DMURS Statement of Design Consistency

Proposed Strategic Housing Development at Auburn, Malahide Road

**Title: QUALITY AUDIT
 INCLUDING
 Road Safety Audit, Access Audit, Cycle Audit and Walking
 Audit.
 For;
 Proposed Strategic Housing Development at Auburn,
 Malahide, Co. Dublin**

Drawing 19-020 P103 Rev A

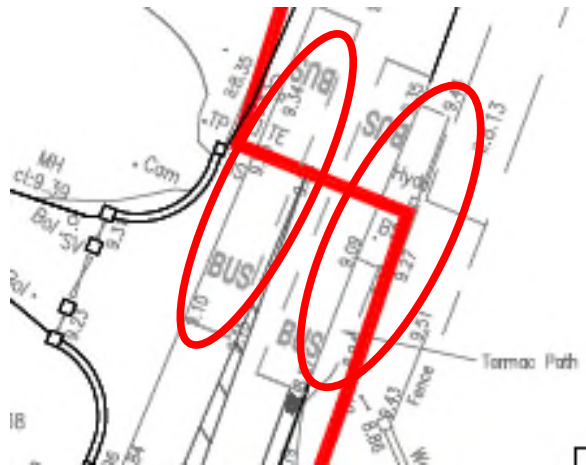
There are bus stops on both sides of the R107 immediately North of the proposed signalised junction. There is a risk that the existing hard standing facilities for these bus stops will not be adequate to cater for the additional usage that may come from the proposed development. It was observed during the site visit that there are open drains behind the bus stops and that the footpaths are narrow.

It is recommended that the bus stops and paths to the bus stops from the signalised pedestrian crossing be included in the design.

| Paragraph No. in Quality Audit Report | Problem accepted (yes/no) | Recommended measure accepted (yes/no) | Alternative measures (describe) | Alternative measures accepted by Auditors (Yes/No) |
|---|---------------------------------|--|---|--|
| 3.3 | Yes | Yes | <p>We have now provided footpaths and crossings to the bus stops.</p> | Yes |

Drawing 19-020 P103 Rev A

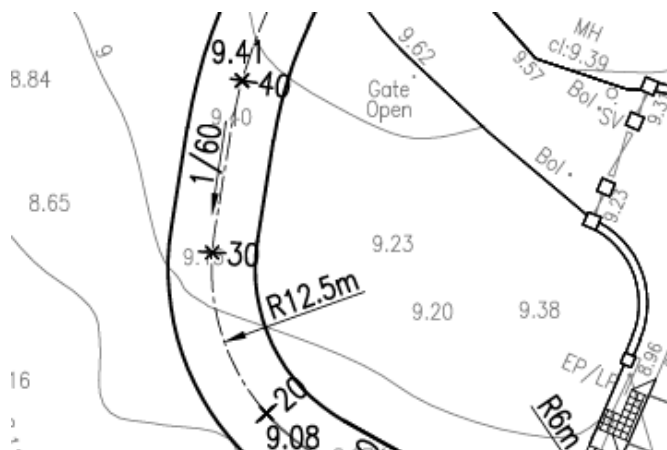
The main access road to the development is proposed to be 5.0m wide. It has however some low radius bends which aid with traffic calming. There is a risk of side-swipe collisions if larger vehicles meet at the tight bends.

It is recommended that a swept path analysis be carried out at a suitable travelling speed to ensure that regular vehicles using the access road such as light vans, SUVs etc. can easily pass all along the route. If this cannot be achieved some local curve widening may be required.

| Paragraph No. in Quality Audit Report | Problem accepted (yes/no) | Recommended measure accepted (yes/no) | Alternative measures (describe) | Alternative measures accepted by Auditors (Yes/No) |
|---|---------------------------------|--|---|--|
| 3.4 | Yes | Yes | <p>Swept path analysis has been carried out at the access road to ensure large vehicles can pass along the route.</p> | Yes |

Drawing 19-020 P103 Rev A, Main access Road Chainage 300.

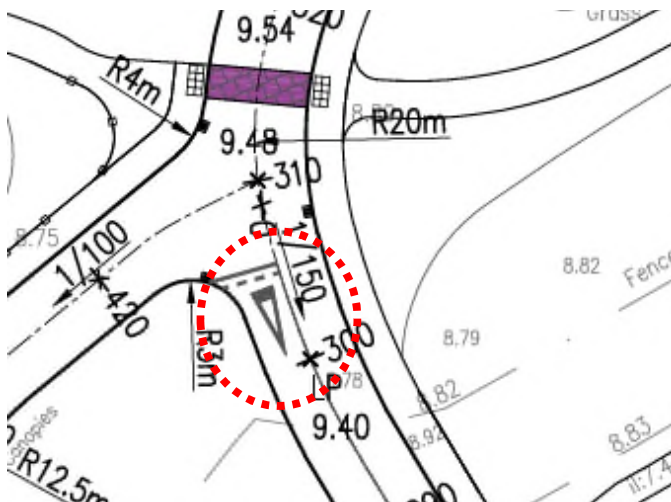
There is a yield road marking symbol shown on the main access road at chainage 300. The horizontal alignment and junction layout suggests that drivers travelling northbound would have priority. There is a risk that the road markings and associated signage would not be observed by drivers and this could lead to side-impact collisions.

It is recommended that the priority be changed. It is also recommended that the yield control be changed to a stop control to promote lower turning speeds.

| Paragraph No. in Quality Audit Report | Problem accepted (yes/no) | Recommended measure accepted (yes/no) | Alternative measures (describe) | Alternative measures accepted by Auditors (Yes/No) |
|---|---------------------------------|--|---|--|
| 3.5 | Yes | Yes | <p>All three arms of the junction are now Stop control junctions, and the intersection includes a raised table to ensure the road markings and associated signage are observed by drivers.</p> | Yes |

Drawing 19-020 P103 Rev A, Carey's Lane Access Road, Chainage 310.

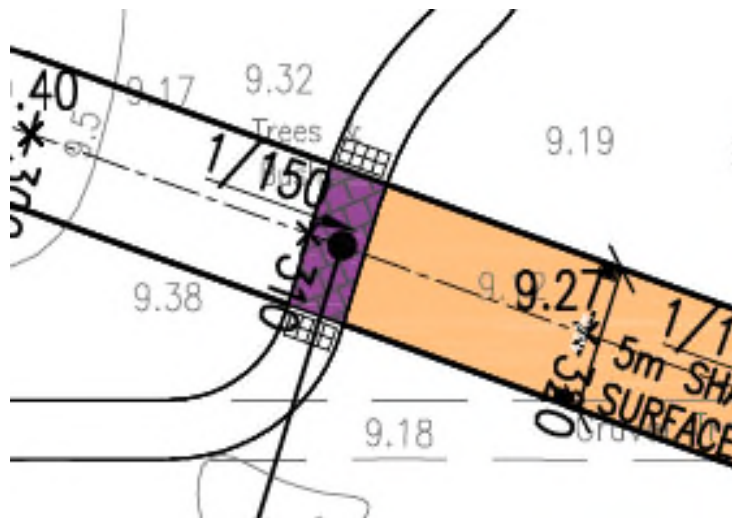
It is proposed to provide granite setts or similar at the start of the shared use area. There is a risk that pedestrians entering at this start of the shared use area might not be expected by drivers and they may not have adjusted their speed at that point.

It is recommended that the start of the shared use area be moved westwards and that the shared use area be raised to highlight to all users the different type/nature of street that they are entering.

| 3.6 | Yes | No | This is no longer proposed as a shared use area. | Yes |

Drawing 19-020 P103 Rev A, Carey's Lane Access Road, Chainage 280.

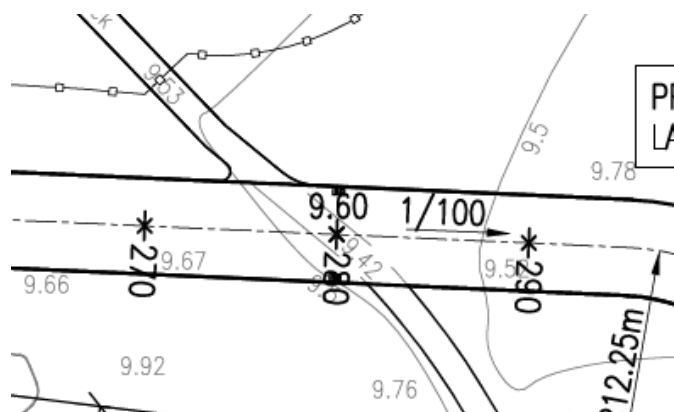
A footpath crosses the access road at a skew angle and without warning for pedestrians or drivers. This could result in conflict

It is recommended that the crossing be treated similar to other crossings with dropped kerbs and tactile paving. The path should be realigned locally to have a perpendicular and hence the shortest crossing for pedestrians which could be easily navigated by partially sighted or blind pedestrians.

| 3.7 | Yes | Yes | The crossing now incorporates dropped kerbs and tactile paving. However, this is an existing historic pathway that is to be maintained and cannot be realigned. There is an adjacent crossing provided that is perpendicular to the road and is appropriate for vulnerable users. | Yes |
